Loreto Normanhurst Concept Plan and Stage 1 Works – SSDA 8996 Request for Information

Table 1 Summary of query and responses

Figure 1 Amended Civil Drawing – location of the two (2) relocated parking spaces

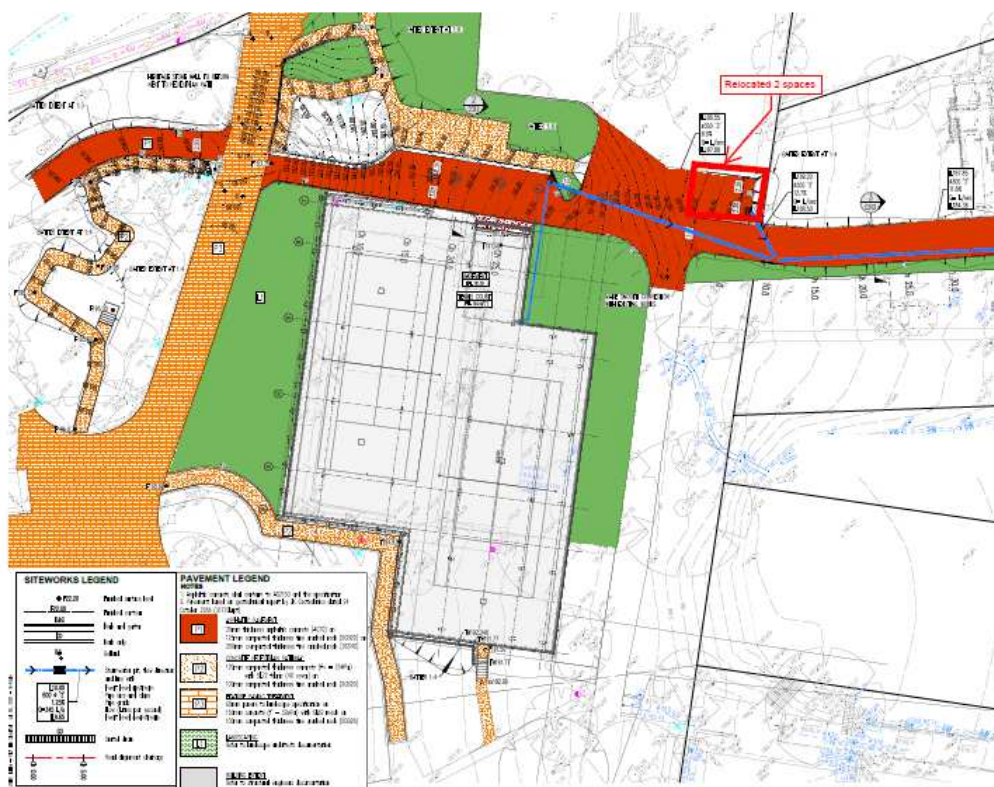
Minor design changes are proposed to the P1A Car Park to better align the design of the car park and address BCA/NCC items which have arisen during the detailed design. Accordingly, the car park will relocate two (2) spaces from within the P1A car park to an existing at-grade car park located near to the P1A car park (see **Figure 1**), reducing the number of parking spaces within P1A to 40 spaces. The overall number of parking spaces will continue to be delivered in accordance the Infrastructure Delivery Staging submitted with the Amended Concept Proposal and Stage 1 DA (dated 8 February 2021).

The two car parking spaces are proposed to be relocated to existing car parking spaces that were previously marked to be removed for the provision of landscaping. To facilitate the retention of these two parking spaces, the through site link road is also narrowed to 3.5 metres wide for a 6 metre long section.

Amended Civil Plans are provided at **Appendix G**. Amended P1A Car Park Plans are provided at **Appendix H**.
